Work Order ID 93792***93792***

D3290-041 REPLACEMENT WINDOW ASSEMBLY

DRAWING NO. D3290	TITLE REPLACEMENT WINDOW ASSEMBLY	REV. C	DART AEROSPACE LTD ENGINEERING ORDER		D.E.O. NO. D3290-C-1	SHEET NO. SHEET 1 OF 1	SCALE NTS
DRAWN <i>qp</i>	CHECKED <i>ls</i>	MFG. APPR. <i>E</i>	APPROVED <i>MD</i>		DE APPR. <i>th</i>		
DATE 09.09.18	DATE 09.09.18	DATE 09.09.18	DATE 09/09/21		DATE 09/09/21

D3290-1 FRAME

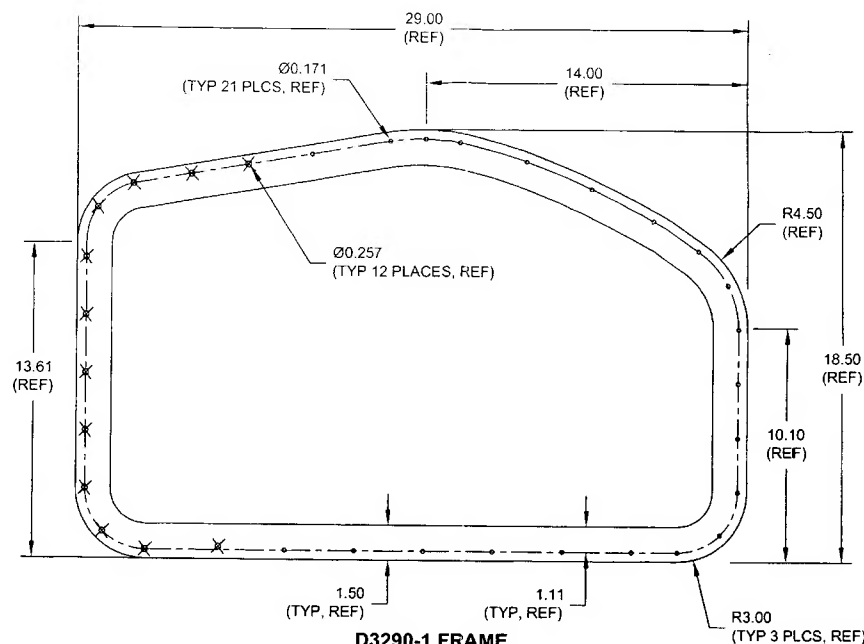
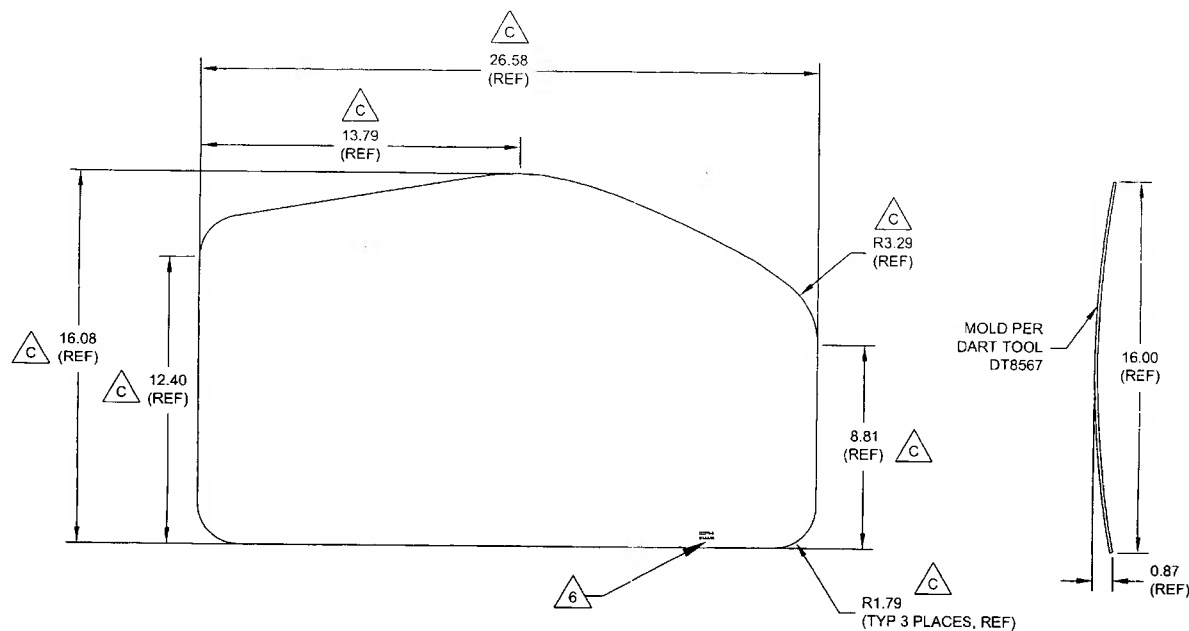
CHANGE MATERIAL THICKNESS OF D3290-1 FRAME TO 0.063 FROM 0.040. REF PAR 09-033.

MATERIAL CALL-OUT OF D3290-1 FRAME ON SHEET 1 IS AMENDED AS FOLLOWS:

- 1) MATERIAL: 6061-T6 (OR 6061-T62) ALUMINUM SHEET ~~0.040 THICK~~ 0.063 THICK (REPLACE)
 PER AMS-QQ-A-250/11 OR AMS 4025 OR AMS 4027
~~(REF. DART SPEC. M6061T6S.040)~~ REF. DART SPEC. M6061T6S.063 (REPLACE)
 OR
 5052-H32 ALUMINUM SHEET ~~0.040 THICK~~ 0.063 THICK (REPLACE)
 PER AMS-QQ-A-250/8 OR AMS 4016
~~(REF. DART SPEC. M5052H32S.040)~~ REF. DART SPEC. M5052H32S.063 (REPLACE)
